# UNITED STATES PATENT AND TRADEMARK OFFICE

APPLICATION NO.	FILING DATE	FIRST NAMED INVENTOR	ATTORNEY DOCKET NO.	CONFIRMATION NO.
09/993,299	11/23/2001	David L. Reynolds	8080	5366

# Office Action Summary

## DETAILED ACTION

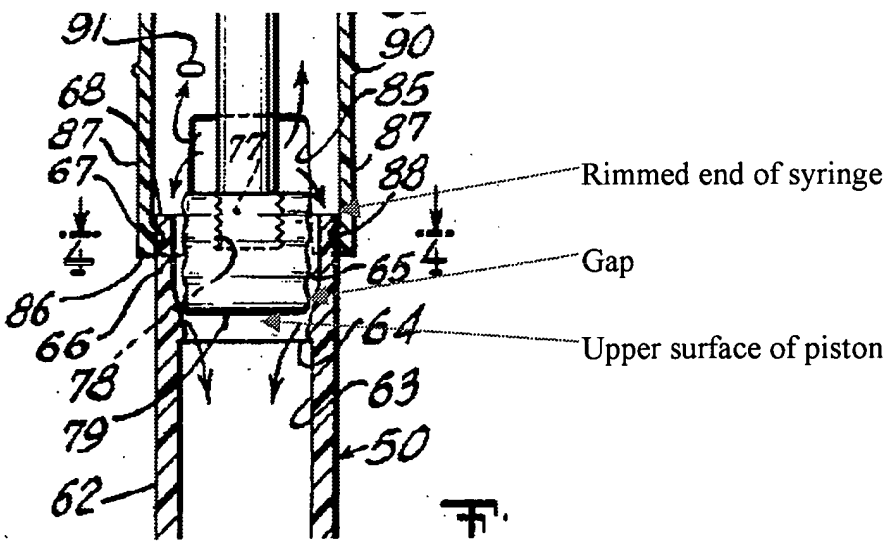
Wilburn discloses a syringe body (50) with a rimmed end (see figure 1). The device also includes a piston (79), a sleeve (82) and piston support means (76). The support means is integrally formed with the sleeve and includes a support surface (77) located radially inwardly of the inner surface of the syringe body side wall and forms a gap (see figures 1, 23 and 25). Looking at figure 1, the base of the sleeve is flat and has a diameter at least as wide as the syringe itself and therefore is sufficient to permit the syringe to stand upright. The sleeve also has an outwardly projecting flange (see figures 23 and 25) that has height. The sleeve also has an inwardly projecting portion detent (88).

Figure 1 (see copy below) shows that the upper surface of the piston is closer to the neck end of the syringe. Additionally, a gap exists between the upper surface and the rimmed end of the syringe body.

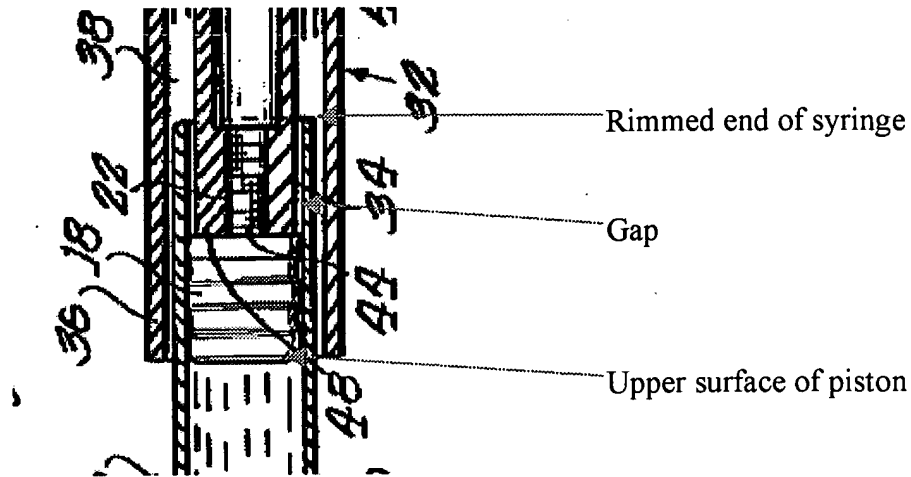
Helixon discloses a syringe body (12) with a rimmed end (see figure 2). The device also includes a piston (18), a sleeve (32) and piston support means (34). The support means is integrally formed with the sleeve and includes a support surface (48) located radially inwardly of the inner surface of the syringe body side wall and forms a gap (38). Looking at figure 2, the base of the sleeve is flat and has a diameter at least as wide as the syringe itself and therefore is sufficient to permit the syringe to stand upright. The support surface (48) is annular with a central aperture (see figures 2 and 3). The piston is supported above the base end of the sleeve when positioned upright (see figure 2 rotate clockwise). As shown in figure 2 the gap (38) thickness is about the thickness of the syringe body wall which forms an annular recess. The bottom of the sleeve forms a bottom wall (40) of the annular recess. The side of the piston forms a hermetic seal with the inner wall of the syringe body (considered inherent for proper functioning of a syringe for injection).

Figure 2 (see copy below) shows that the upper surface of the piston is closer to the neck end of the syringe. Additionally, a gap exists between the upper surface and the rimmed end of the syringe body.

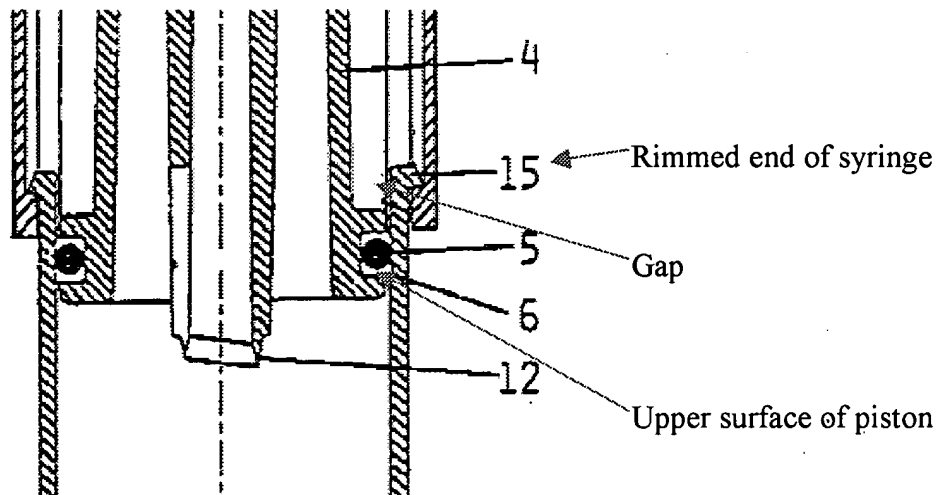
Peterson discloses a dispenser that includes a syringe body (1) with a rimmed end (15). The device also includes a piston (8), a sleeve (14) and piston support means (12). The support means is integrally formed with the sleeve and includes a support surface (see figure 1) located radially inwardly of the inner surface of the syringe body side wall and forms a gap (see figure 1). Looking at figure 1, the base of the sleeve is substantially flat and has a diameter at least as wide as the syringe itself and therefore is sufficient to permit the syringe to stand upright. The sleeve also has an outwardly projecting flange (15) that has height which has a vertical dimension when the syringe is positioned upright. The sleeve also has an inwardly projecting portion detent (shown in figure 1).

Figure 1 (see copy below) shows that the upper surface of the piston is closer to the neck end of the syringe. Additionally, a gap exists between the upper surface and the rimmed end of the syringe body.
